## Assessment Report and Recommendation

PREPARED BY GLN PLANNING FOR CENTRAL COAST COUNCIL

For The Hunter Central Coast Regional Planning Panel (HCCRPP)

Applicant	Central Coast Council
Owner	Central Coast Council
Application No	DA/919/2018
Description of Land	Lot 1 DP 371647, Lot 1 DP 375712, Lot 1 DP 376264, Lot 41 DP 1200210, Lot 51 and 52 DP 561032 and Lot 54 and 55 DP 7527. 99 -107 Sparks Road and Hakone Road Woongarah
Proposed Development	160 Lot Subdivision as Stages 6 and 7, amended February 2020 to 92 residential lots., 1 Mixed Use lot, 2 residue lots and 1 temporary easement and basin lot in Stages 6 and 7.
Site Area	23.84ha
Zoning	B2 Local Centre Wyong LEP 2013
Existing Use	Carpark and road with existing closed road
Estimated Value	\$11,200,000

**Figure 7 Extract submitted Site Analysis Plan**

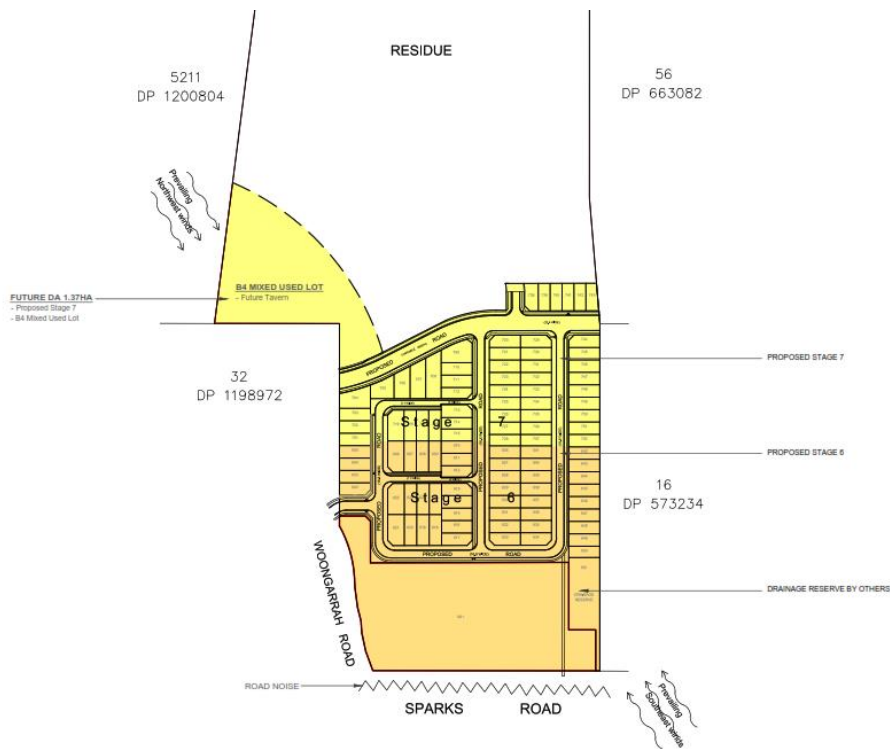
The submitted site analysis plan is inadequate to identify the opportunities and constraints of the site. As the proposed development seeks to provide for an alternate road layout than anticipated by WDCP it would be reasonable to explain the proposed variations by reference to the factors that give rise to the requirement variations. The submitted plan does not indicate connections and relationship to adjoining development nor a possible lot layout for proposed Lot 601.

**Figure 8** Proposed street pattern and roads identified.

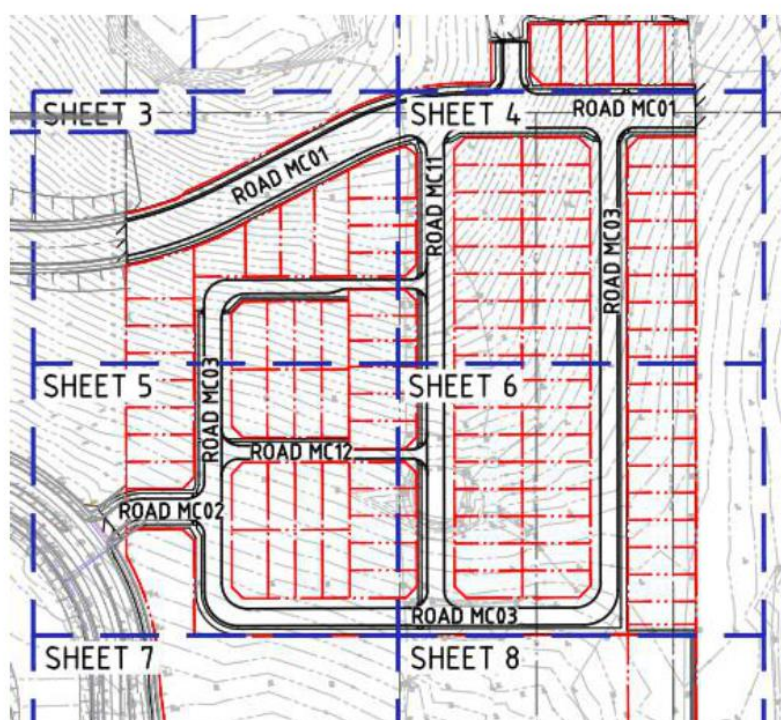
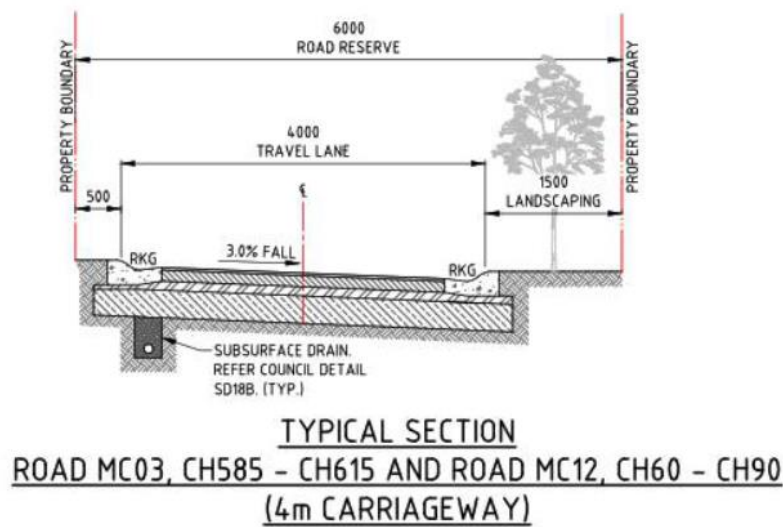
The proposed variations to road layout are not supported by Council's engineers for reasons beyond the road layout and include below minimum or out of context minimum widths and corners and intersections which are required to be widened to accommodate turning paths. The section proposed and contained in **Figure 9** above does not provide any width to accommodate the provision of utilities. The applicant contends the proposed narrower road widths act as traffic measures, which Council's engineers indicate can be delivered in an alternative manner to provide a better outcome.

In addition on planning grounds most relevantly the future resolution of streetscape are not successfully resolved by the proposed 4m carriageway widths. These lots namely Lots 713 and 612 (refer **Figure 10** below) do not provide sufficient frontage or access within the 363m<sup>2</sup> and 316m<sup>2</sup> respectively for driveways for future dwellings. Proposed footpaths terminate at the rear fences of these lots which will require pedestrians to access the road at the road intersections. No on street parking will be available for proposed lots 712, 713, 612 and 613 in the immediate vicinity of the associated frontages. Further these corner allotments are not larger lots to accommodate additional setbacks. The amended road and lot pattern prevents the provision of pedestrian access to the school along the eastern boundary of the site.

**Figure 10 Extract of Proposed subdivision plan**

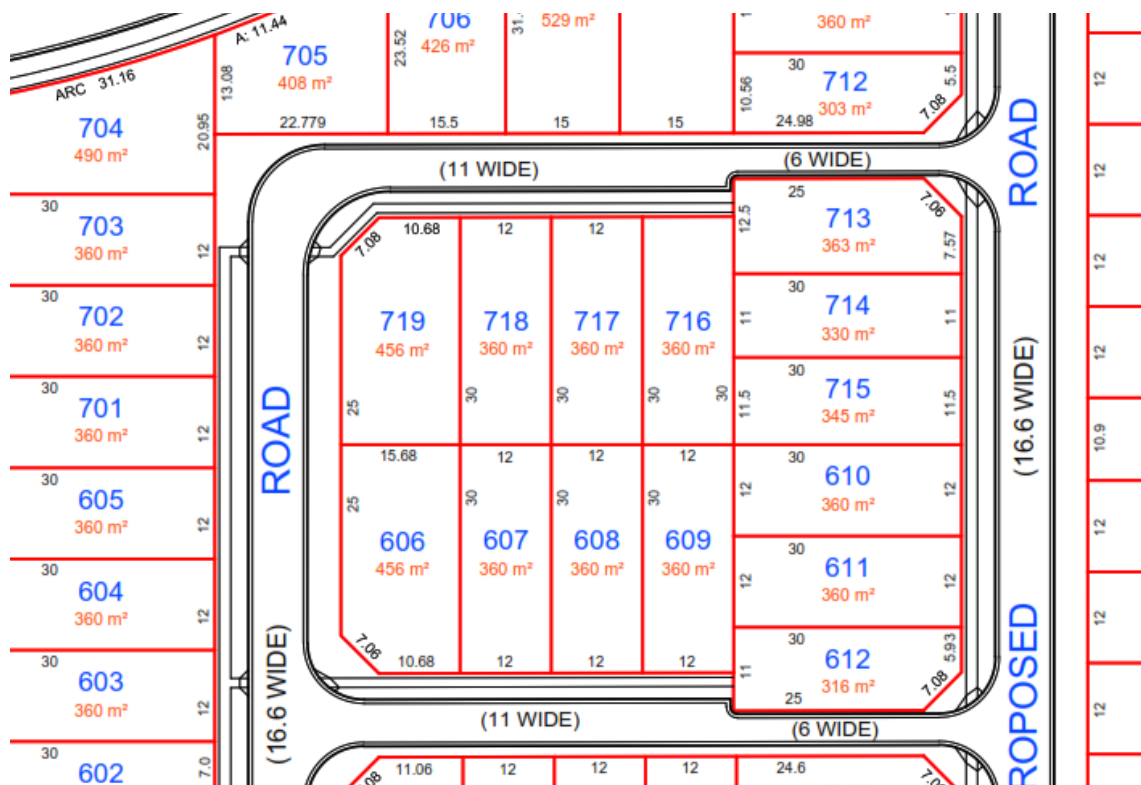
The proposal does not satisfactorily address the matters identified in Section 3.4 of Part 4 of WDCP and does not warrant variation in this instance. Compliance with the minimum road reserve widths should be maintained.

**Figure 14 Proposed Road Pattern**

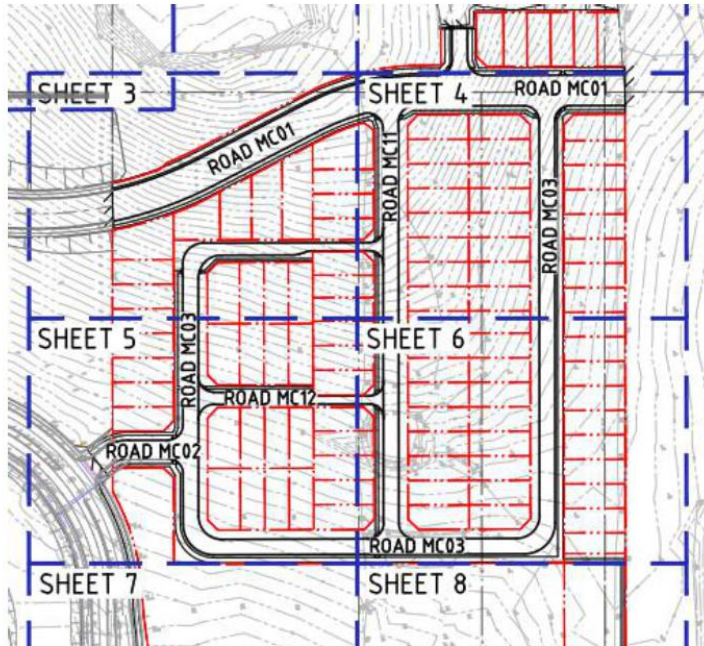
The proposal seeks a non numerical variation to Clause 2.4 of the DCP which relates to the road layout and street types. The internal roads proposed which are identified as being Type 11 are all proposed to be varied from the DCP standards. The north south Type 11a road is deleted along the eastern boundary of the site.

The proposed variation to the road layout pattern is not supported as detailed earlier in this report.
